SAN FRANCISCO PLANNING DEPARTMENT

Certificate of Appropriateness Case Report

HEARING DATE: FEBRUARY 18, 2015

Filing Date: October 8, 2014
Case No.: **2014.1422A**
Project Address: **900 NORTH POINT STREET: GHIRARDELLI SQUARE**
Historic Landmark: No. 30 – Ghirardelli Square
Zoning: C-2 (Community Business) District
40-X Height and Bulk District
Waterfront Special Use District, subarea #2
Block/Lot: 0452 / 002
Applicant: Elisa Skaggs
Page & Turnbull, Inc.
417 Montgomery, 8th floor
San Francisco, CA 94104
Staff Contact Pilar LaValley - (415) 575-9084
pilar.lavalley@sfgov.org
Reviewed By Tim Frye – (415) 575-6822
tim.frye@sfgov.org

TERRACE PLAZA PLANS: PROPOSED PAVING PLAN

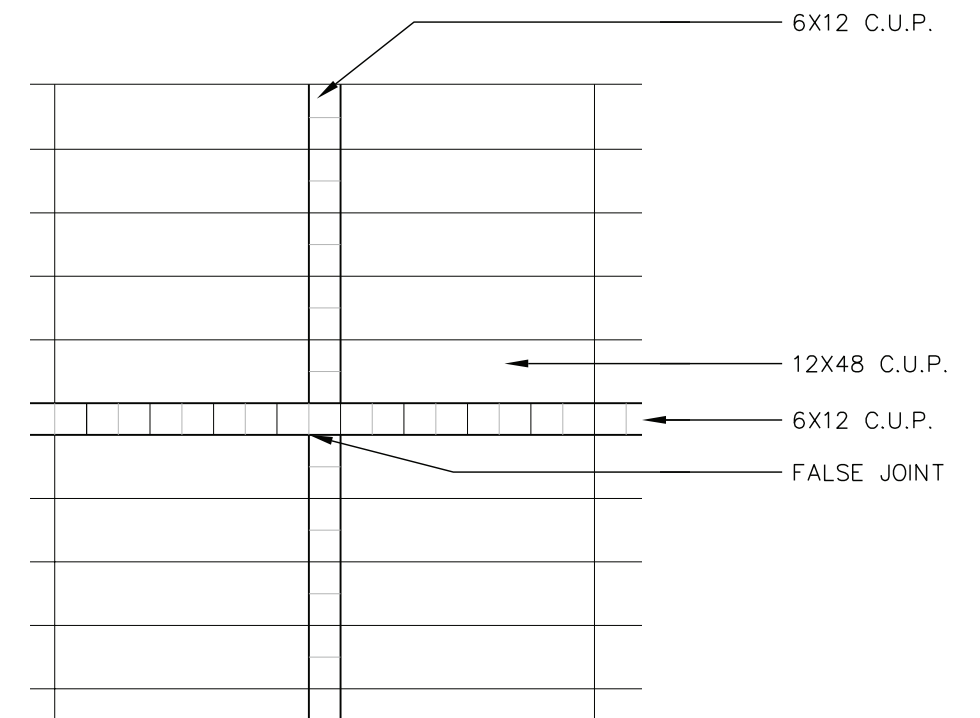
This original paving exhibits much deterioration and requires removal to address waterproofing issues. The proposed project will remove all (historic and non-historic) paving within Terrace Plaza, including along north façade of Mustard Building, within passageway to North Point Street, and at ramp leading to Fountain Plaza in order to install a new waterproofing membrane and paving systems. Poured-in-place concrete will be installed at the on-grade locations, and along the north side of the Mustard Building. Concrete pavers on a pedestal system will be installed in the raised portion of the plaza; pavers will be 6 inch by 12 inch and 12 inch by 48 inch with a small (3/16") joint between pavers and a false joint to highlight the light-colored grid. All new paving will closely match the original Halprin-era finish (pebbled, or course aggregate, concrete) with a 6 inch band of light-colored concrete. The new paving will reestablish a regular grid pattern within the Plaza with the light-colored edging changing from 5 inches to 6 inches; the pedestal paver system cannot accommodate pavers any smaller than 6 inches and the project sponsor would like the appearance of the entire Plaza to be consistent once the new paving systems are installed. This appears to be a minor change that is compatible with the original paving.

Although the loss of historic paving is unfortunate, existing paving appears to be deteriorated such that a new paving and waterproofing system is justified. New paving in both the poured-in-place and pedestal paver systems will closely match existing in texture, color, design, and, with the poured-in-place concrete, materials, in a manner that is consistent with the *Secretary's Standards*.

TERRACE PLAZA PLANS: SEATWALL

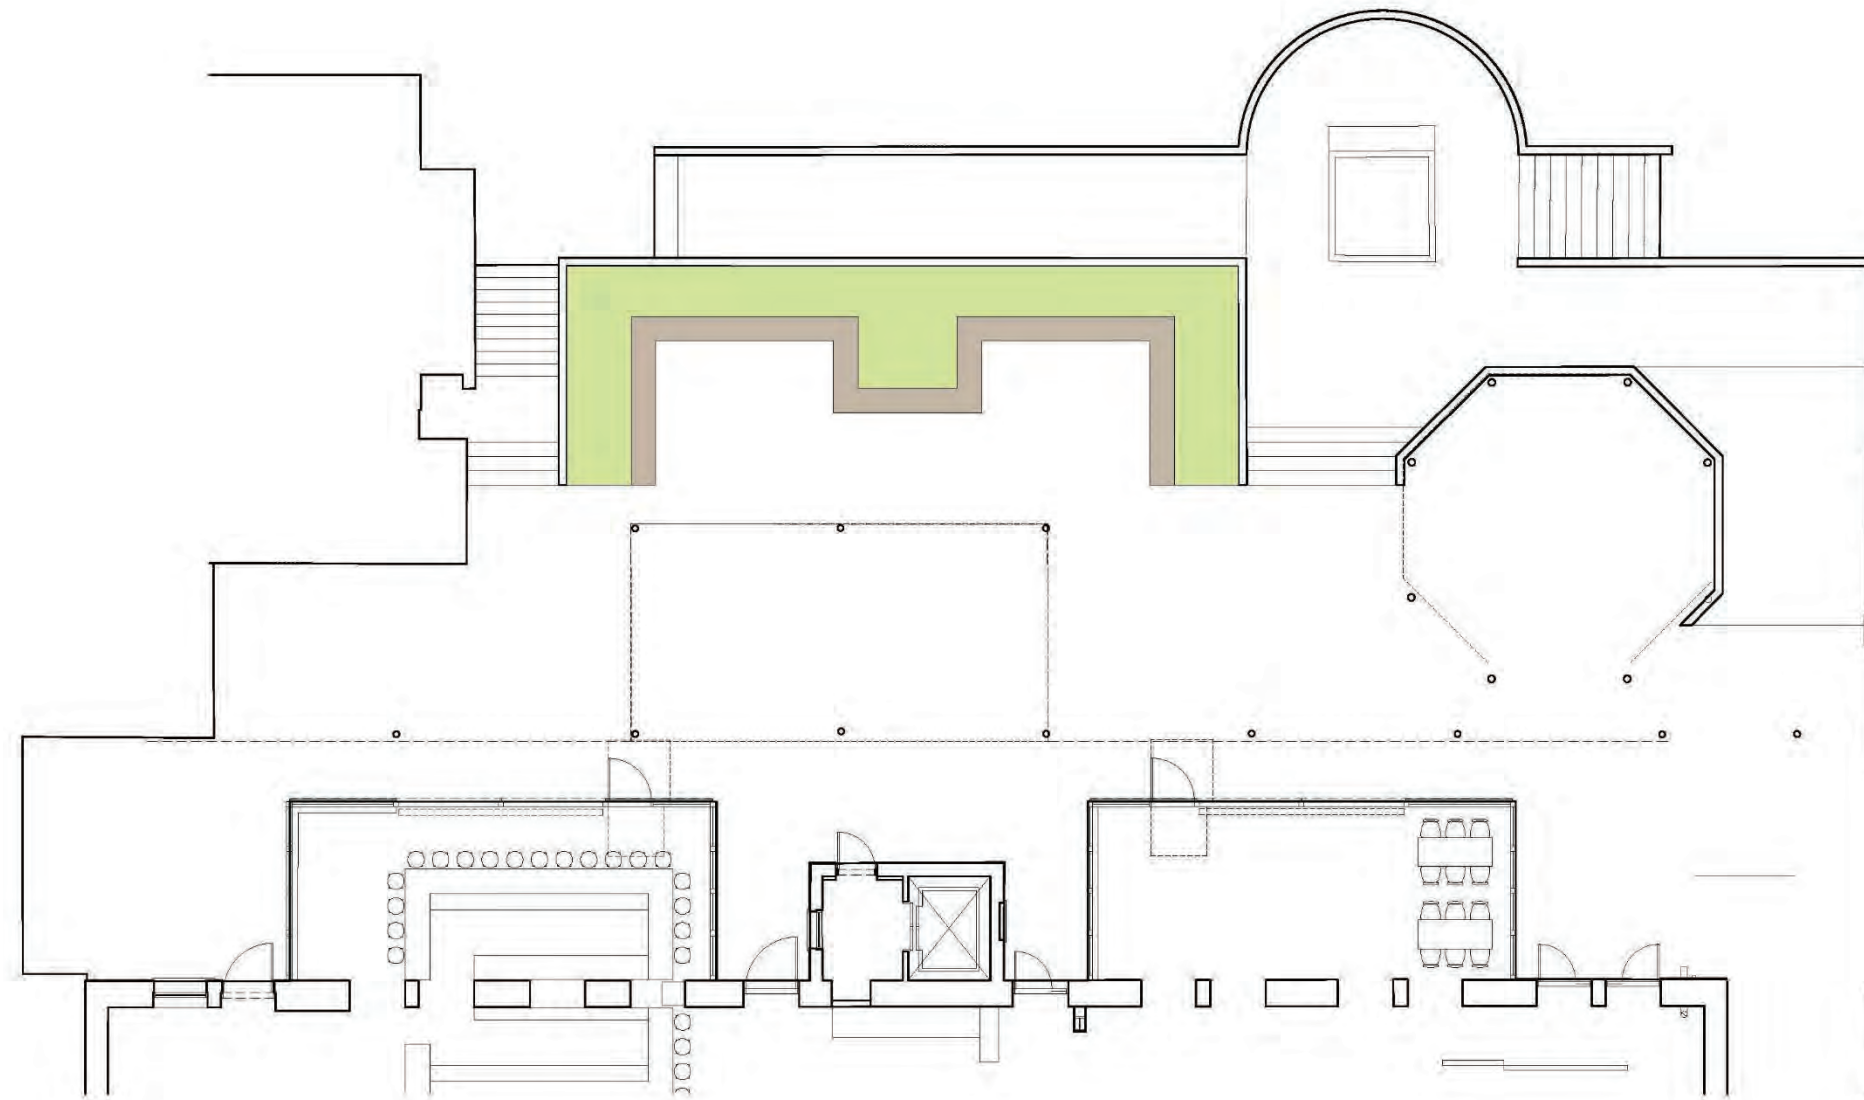
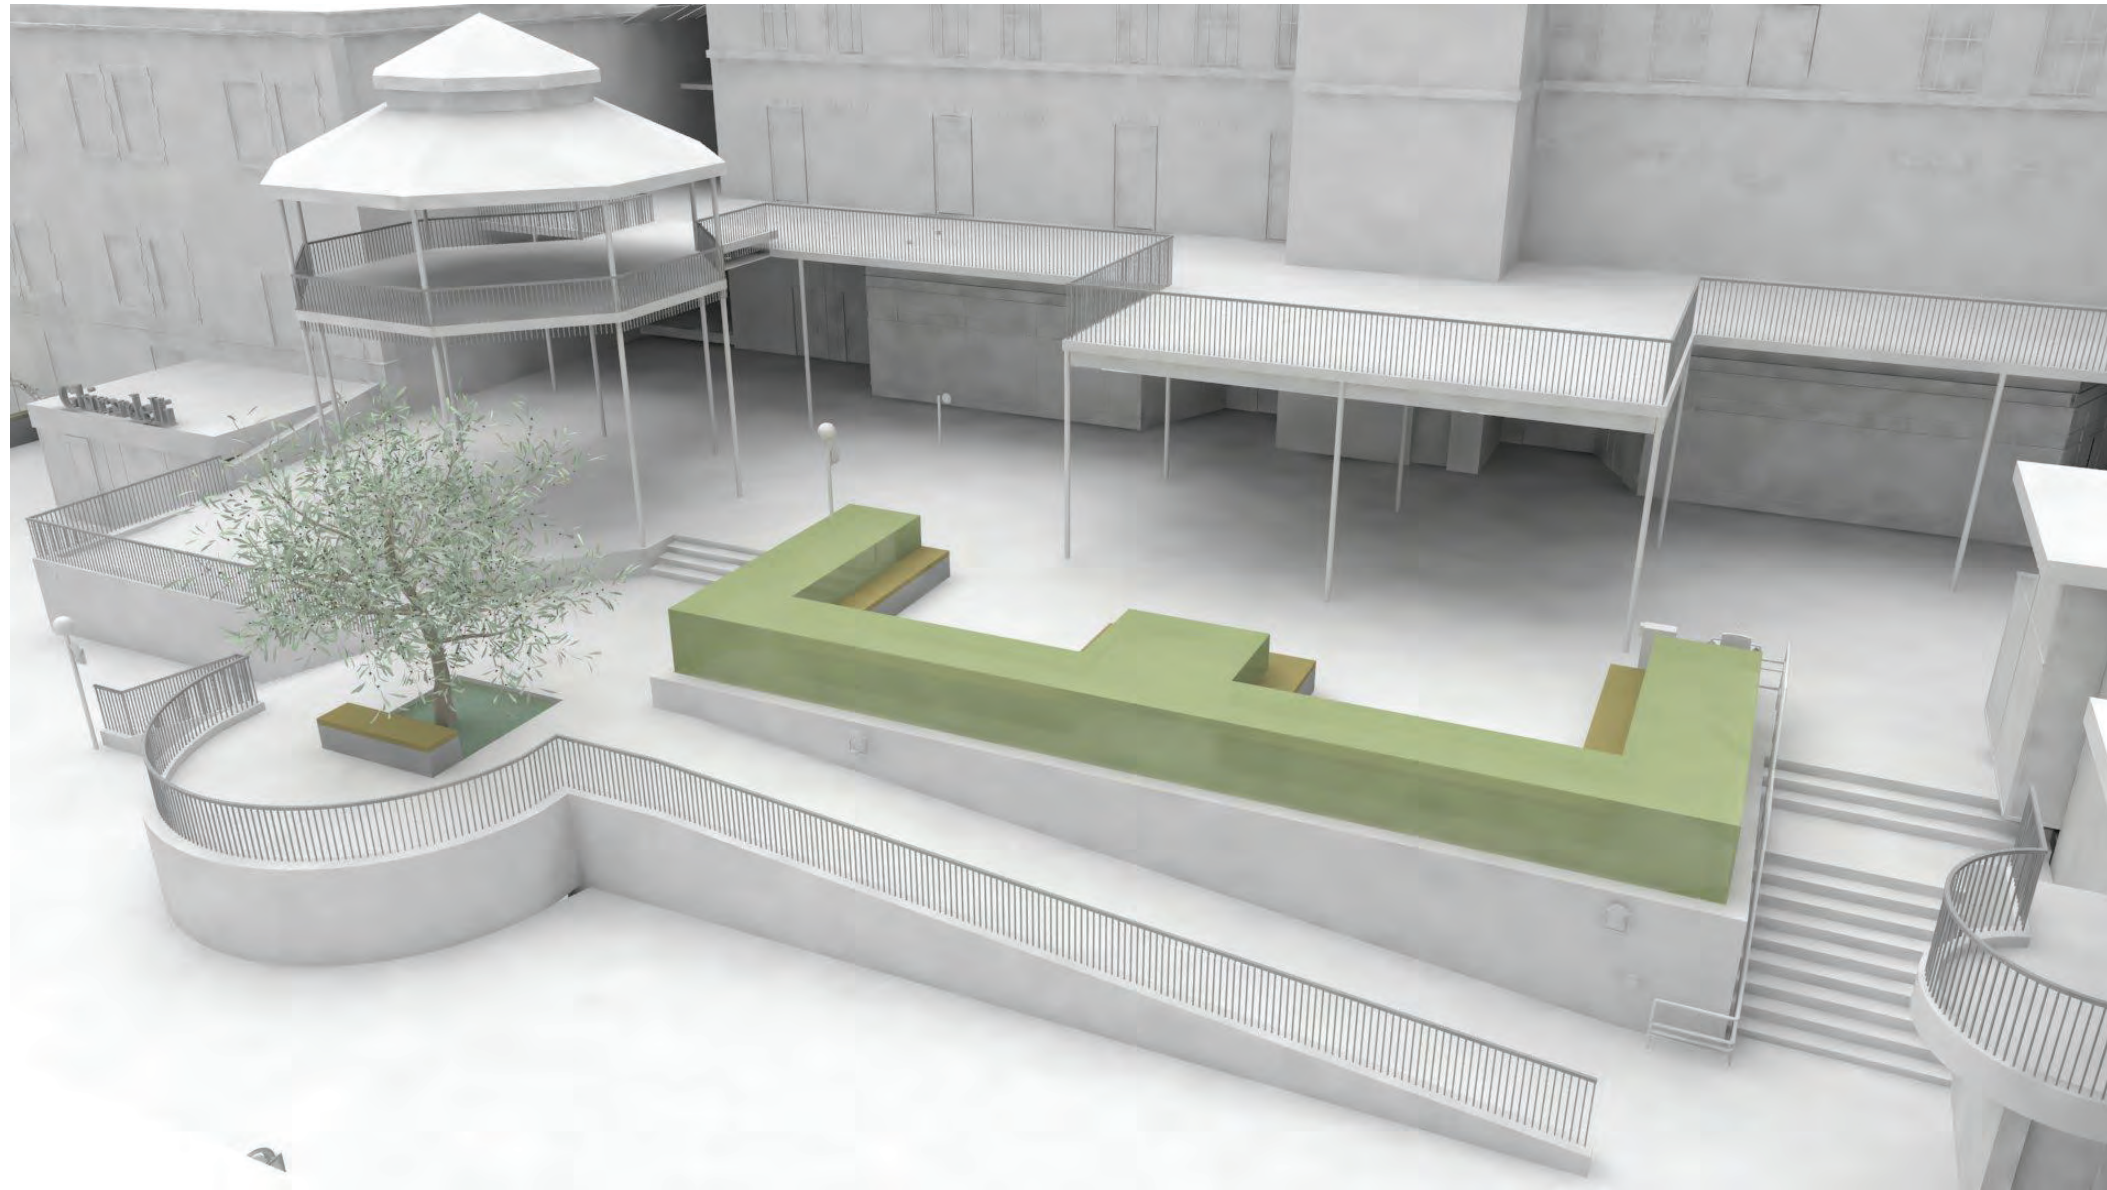
The existing planter at the north edge of the Plaza was designed by Halprin, but it was substantially altered in 1984 through chamfering of several corners and total reconfiguration of the south side of the feature. The proposed project will infill chamfered corners to restore the extent and appearance of the north wall of the planter. Infill at the previously chamfered corners will recreate the board form concrete finish of the original, extant portion of the wall. At the east, south, and west sides, new planter walls will be installed. The south side of the planter, which is effectively below grade due to the raised level of the Plaza, will be defined by a new built-in concrete bench. The bench, which will be constructed of concrete with a reclaimed wood seat, will form an E in plan with the center section popping out in a manner that references the seating nooks in the original Halprin design. The reconfigured planter will be planted in new landscape plantings.

5. *Staff recommends that, where feasible, new landscape plantings evoke Halprin-era landscape design for the site. The project sponsor should seek original landscape planting plans and/or utilize historic photographs to inform future planting plans. Appropriate landscape plant list should be incorporated into updated Design Guidelines for the property (under development). Future landscape plantings, including for the proposed project, shall conform to the updated Design Guidelines.*

5. That, where feasible, new landscape plantings evoke Halprin-era landscape design for the site. The project sponsor should seek original landscape planting plans and/or utilize historic photographs to inform future planting plans. Appropriate landscape plant list should be incorporated into updated Design Guidelines for the property (under development). Future landscape plantings, including for the proposed project, shall conform to the updated Design Guidelines.
